# **CITY OF CONWAY, ARKANSAS HISTORIC DISTRICT COMMISSION**

June 24, 2024 • 5:30pm • 1111 Main Street

### I. Public Hearing Items - Old Conway Design Overlay District

- A. 1704 College Ave (HDR-0624-0083)
- B. 2156 Prince St (HDR-0624-0081)
- C. 504 Monroe St (HDR-0324-0038)

1 East Elevation

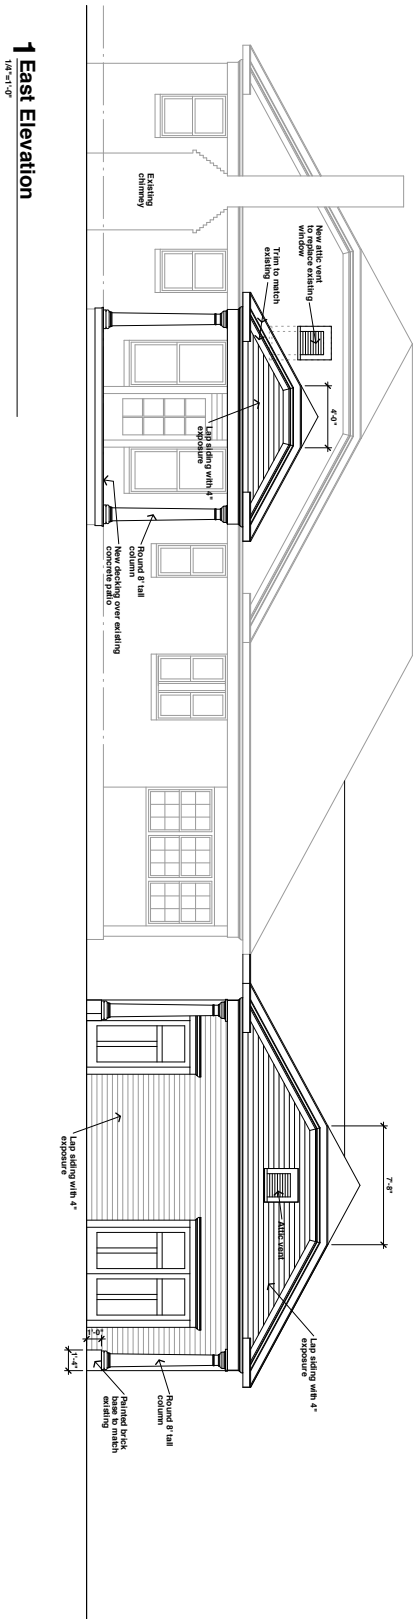
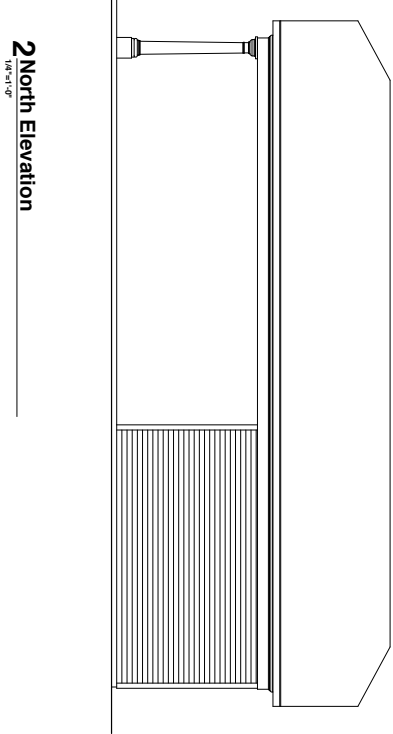
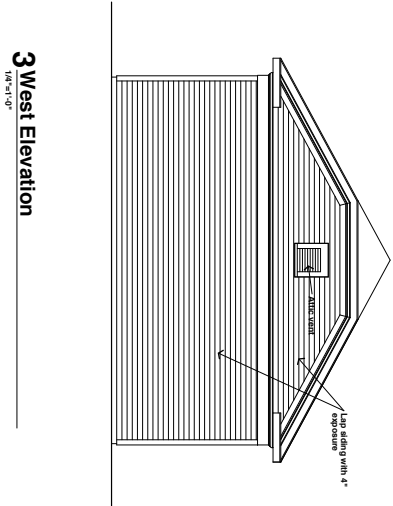
*The existing concrete patio will be enhanced with a gabled roof. It is 10' deep. Decorative elements are present in terms of lap siding and painted columns.*

*The applicant is proposing a wood frame structure, Hardie plank siding and a shingle roof.*

*The applicant is proposing a gable roof with asphalt shingles. This is compatible with the existing residence and surrounding homes.*

1. Applicant must obtain all applicable building permits\* if/when a Certificate of Appropriateness is granted.  
*\*Applicant shall provide proof of appropriate licensure of professionals performing work to the Building Permits Department.*
2. Lighting shall be downward and inward toward the property.
3. Construction shall conform to the attached site plan and elevations.
4. Significant trees over 8" shall be protected. Should any trees need to be removed they shall be replaced at a 1:1 ratio with a tree from the approved tree species list.
5. Driveway shall be concrete ribbon, or permeable pavers.

1 SITE PLAN  
1" = 10'-0"

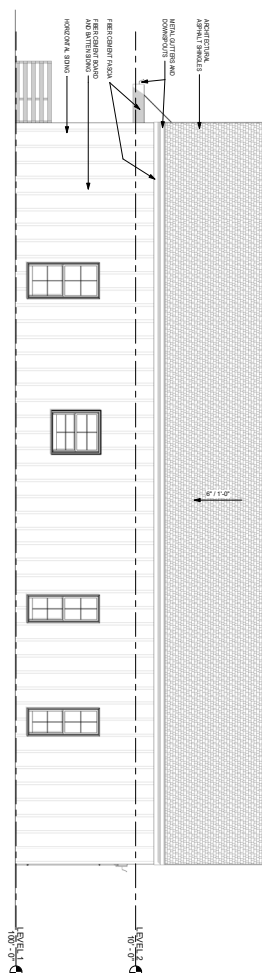
**Setbacks and Spacing.** Front setbacks are allowed within a range of 85% to 115% of the average front setback of the area. The average front setback for the area is 43', based on two adjacent homes. The applicant is proposing a front setback of 46'11".  
*The proposed setback is within the permissible range and meets this requirement.*

**Driveway / Parking.** Parking in the front yard is not permitted. Parking is to be placed at the rear or side. Driveways should be concrete, pavers, or permeable paving and sharing of driveways is encouraged.  
*The applicant has indicated a driveway off of Prince St near the west property line. The width of the driveway is 16' with no length provided. Material used for the parking surface is also not provided. The plans cannot be adequately evaluated due to a lack of information on the plans for driveways.*

1. Applicant must obtain all applicable building permits\* if/when a Certificate of Appropriateness is granted.  
*Applicant shall provide proof of appropriate licensure of professionals performing work to the Building Permits Department.*
2. Overall height of the structure must be compatible to those found in the area.
3. Driveway shall be concrete, pavers, or permeable paving.
4. Any damage to existing sidewalk during construction must be repaired by the applicant.
5. Care should be taken to preserve all significant trees on the property. Any canopy tree removed must be replaced by a canopy tree from the approved tree list.
6. HVAC must be screened from public view.

2 FRONT ELEVATION  
1/4" = 1'-0"

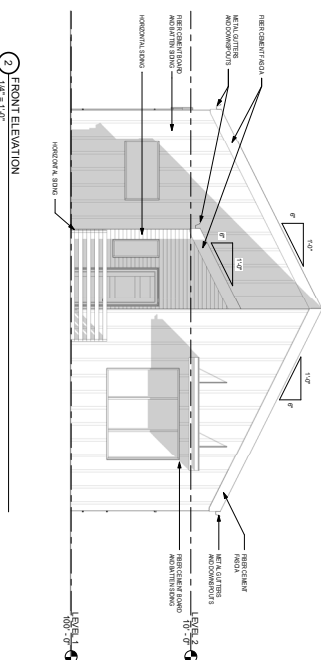
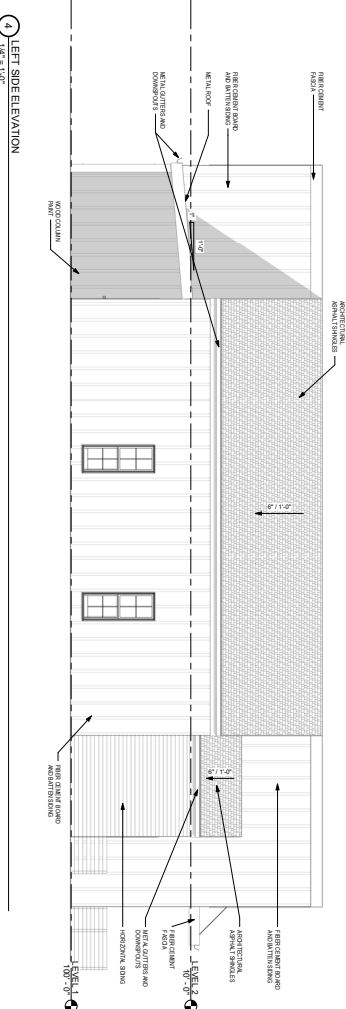
**Height/Width/Directional Expression.** The height/width and directional expression of the structure should relate to historic patterns in the neighborhood.  
*The height of the structure was not provided. The width at 33'11" will not be out of scale of the pattern of the neighborhood. The structure will be one story. There are predominantly one-story structures in the immediate vicinity. The area features a mix of building widths, with similarly narrow structures adjacent to the proposed site.*

**Façade, wall area, rhythm.** New facades shall be compatible with those of the surrounding area. 25-40% of front façades should contain windows. Window and door openings should relate to the size and proportions contained in the surrounding area.  
*All elevations contain windows including several on the front facade. A calculation of the elevations will be required to ensure 25-40% contains windows.*

*No shutters are being proposed which is desirable. The applicant is proposing a gable roof with awnings in the front and rear. This is compatible with surrounding homes.*

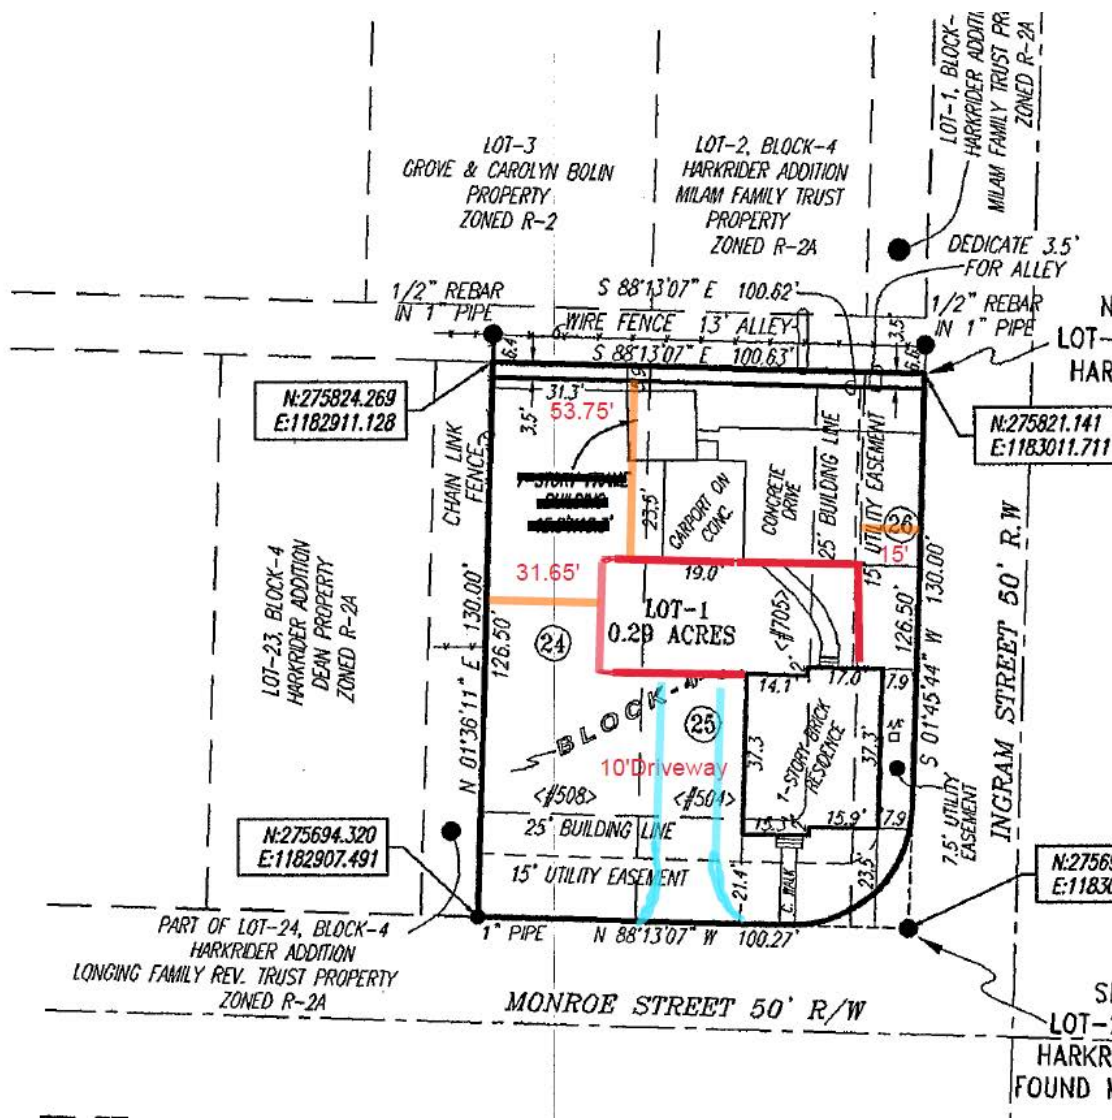
**Setbacks and Spacing.** Front setbacks are allowed within a range of 85% to 115% of the average front setback of the area. The secondary front shall have an 8ft minimum setback; 6ft side yard setback; and 5ft setback in the rear to conform to fire code. *The proposed setback meets the requirements. The addition is 53' from the rear, 15' from the secondary front, over 50' from the primary front, and 31' from the side.*

**Driveway / Parking.** Parking in the front yard is not permitted. Parking is to be placed at the rear or side. Driveways should be concrete, pavers, or permeable paving and sharing of driveways is encouraged. *There is an existing, concrete driveway and parking pad to the rear of the existing structure with access from Ingram St. This project includes a proposal for an additional 10' driveway to the western side of the residence with access from Monroe St. The driveway will need to be concrete ribbon, or permeable pavers.*

*The applicant proposed brick siding and asphalt shingles.*

*No shutters are being proposed which is desirable. The applicant is proposing a gable roof with asphalt shingles. This is compatible with surrounding homes.*

*No HVAC equipment is shown on the site plan.*

4. Windows shall be at least one-over-one (not fixed windows). If muntin bars are used, they must be true divided lights.

5. Driveway shall be concrete, pavers, or permeable paving.

7. HVAC equipment shall be screened from public view.
